GE Hitachi Nuclear Energy

MFN 09-388

Subject: **Response to Portion of NRC RAI Letter No. 323 Related to ESBWR Design Certification Application – DCD Tier 2 Section 3.8 – Seismic Category I Structures; RAI Number 3.8-94 S04**

RAI Number 3.8-94 S04

Figure 3.8-94(20) FRS (Compared with the DAC3N) – RPV Top Y

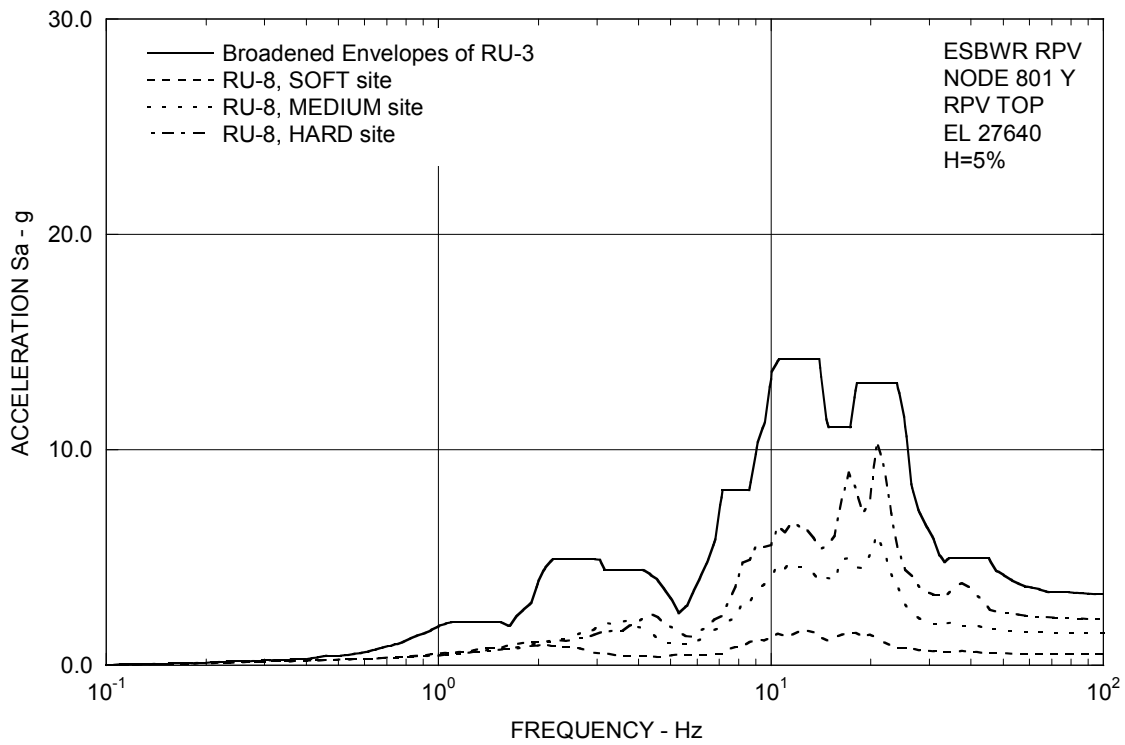
- I) *In several of the enveloping floor response spectra (e.g., Figures 3.8-94(19), (20), and (22), the staff noted that “valleys” exist between successive peaks in the low frequency region, up to approximately 5 Hz. If the spectral peaks are influenced by site conditions, it is the staff’s position that these “valleys” should be filled-in to accommodate the expected variability in site shear wave profiles that may be encountered for this generic design. GEH is requested to provide an explanation why these valleys have not been filled-in.*

- I) Sufficient levels of conservatism are already built into the design floor response spectra in the form of enveloping and peak broadening the results of a sufficient number of generic sites under a bounding Certified Seismic Design Response Spectra (CSDRS) ground input motion. To provide additional margins for sites that might have predominant SSI frequencies at the spectral valleys, the spectral valleys of the site enveloping floor response spectra are further filled-in for the generic design floor response spectra. As an example, the original enveloping floor response spectra at the Vent Wall top, which is the same location as shown in Figure 3.8-94(18), is shown in Figure 3.8-94(43) together with its respective enveloping floor response spectra having the spectral valleys filled-in. The site enveloping floor response spectra in DCD Tier 2 Subsection 3A.9.2 will be replaced in Revision 6 with enveloping floor response spectra having the spectral valleys filled-in. DCD Tier 2 Subsections 3A.8.7 and 3A.9.2 will be revised in Revision 6 for clarification with regards to the spectral valleys being filled-in.

Figure 3.8-94(40) RB/FB Layered Site Soil Case RL-2, Time = 7.810 sec

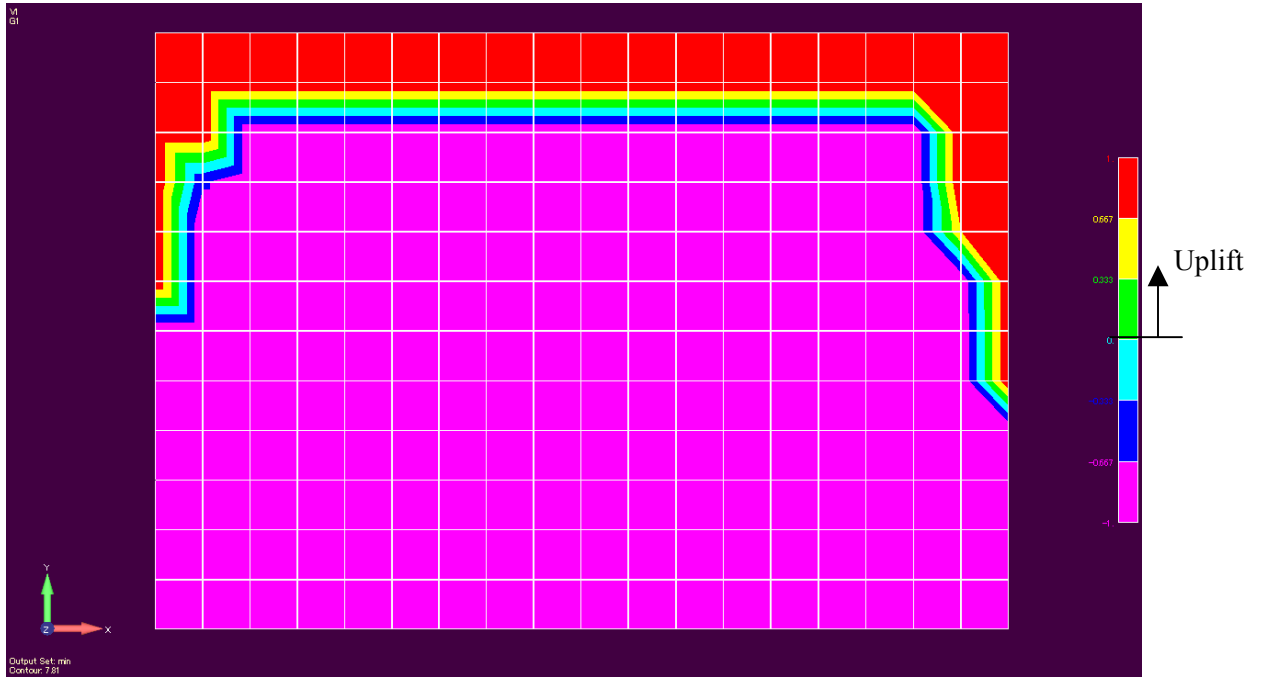
- C) *The forces used to calculate the maximum soil bearing pressures were obtained from the SASSI analyses. These analyses consider that the soil and foundation are integrally connected. However, the bearing pressure calculations on page 11 of 34 show that uplift occurs. Describe the extent of the maximum uplift that occurs in SASSI (denoted by tension in the soil springs), recognizing that this region could expand further if the tension springs would be released using a different computer code. Provide the technical basis for using these seismic loads in the bearing and sliding calculations from the SASSI analyses without consideration of the effects of uplift on the seismic demand loadings. Alternatively, an analysis that considers the nonlinear effect of liftoff due to the three input directions applied simultaneously can be considered.*

The SASSI results for the RB/FB layered site soil Case RL-2 are examined for the extent of maximum uplift when the bearing pressure reaches maximum in combination with dead loads and buoyancy. As shown in Figure 3.8-94(40), the extent of uplift is not extensive and a large portion of the basemat remains in contact with the soil.

Figure 3A.9-2g. Enveloping Floor Response Spectra – CB Top Y

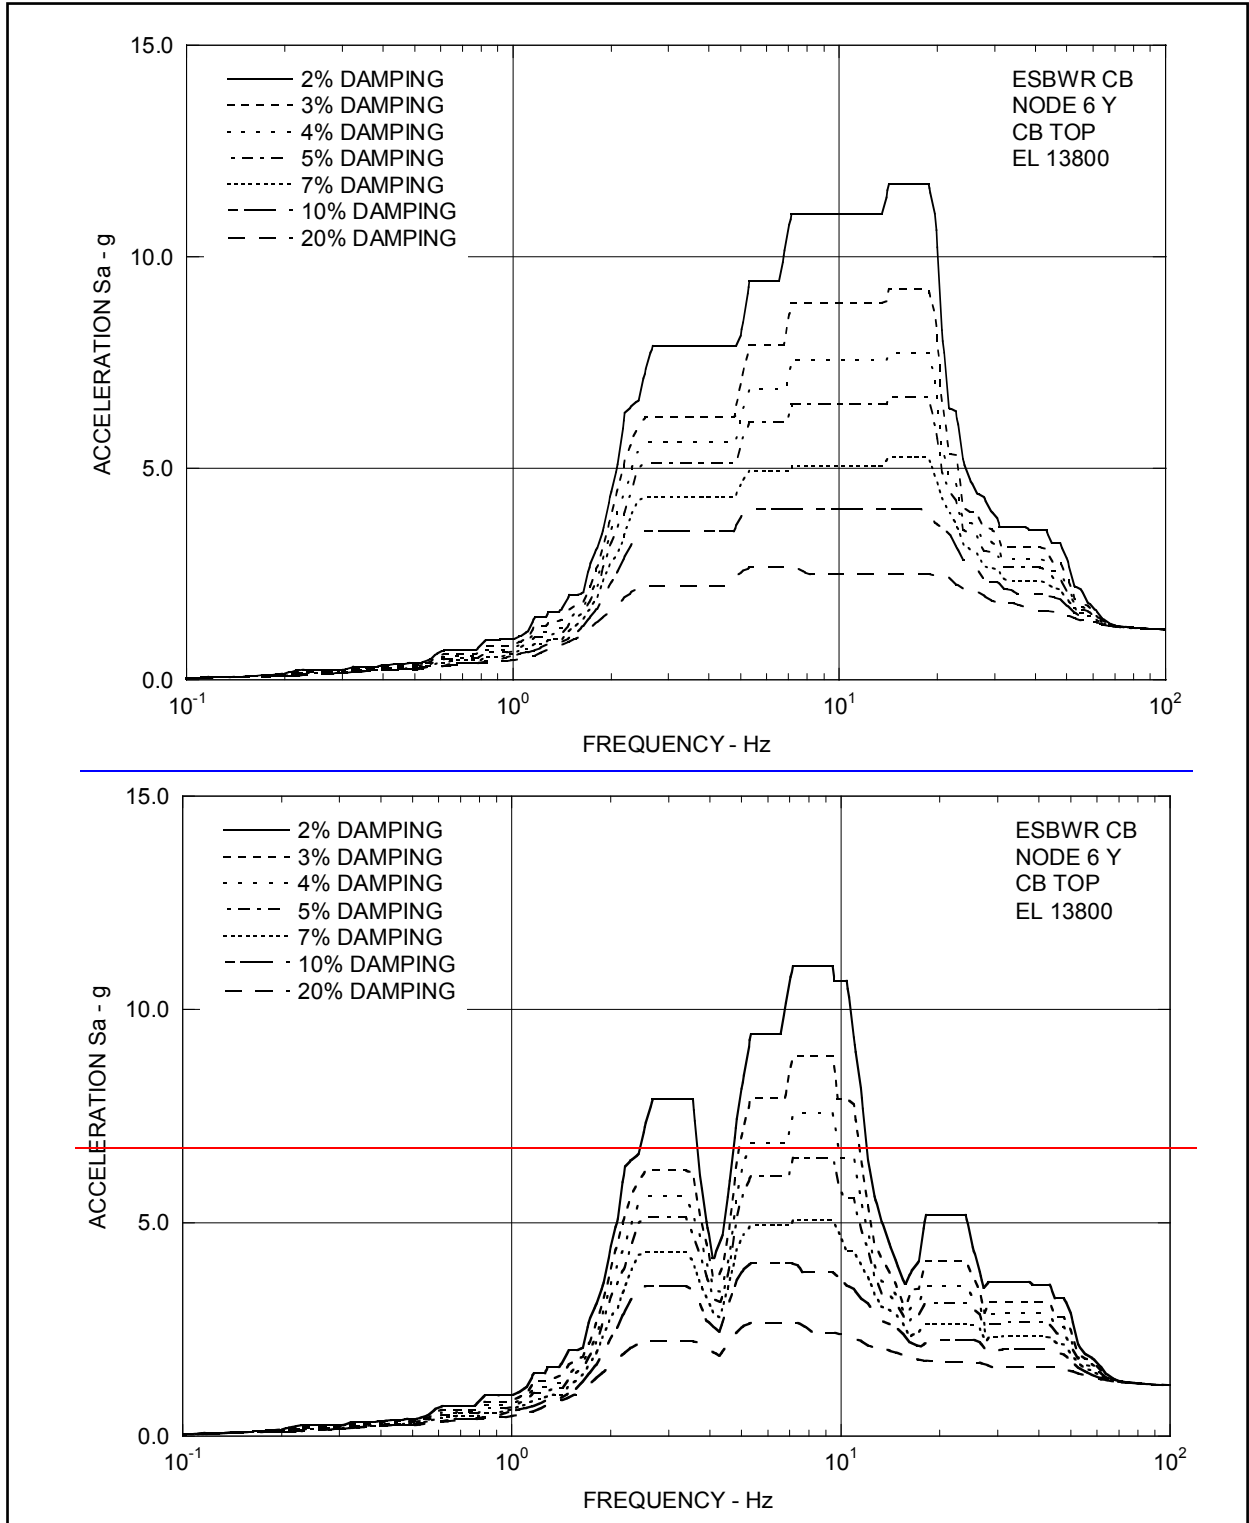
On the other hand, the response spectra of a portion of the CB above ground and the FPE in the FWSC exceeded greater than 10% at the broadened envelope responses of the DAC3N cases in the higher frequency range.

Thus, the SASSI2000 uniform site results of the CB and the FWSC are included where appropriate to obtain the enveloping design spectra. DCD Tier 2 Figures 3A.9-1g, 3A.9-1l, 3A.9-2g and 3A.9-3g will be revised in Revision 6 accordingly.
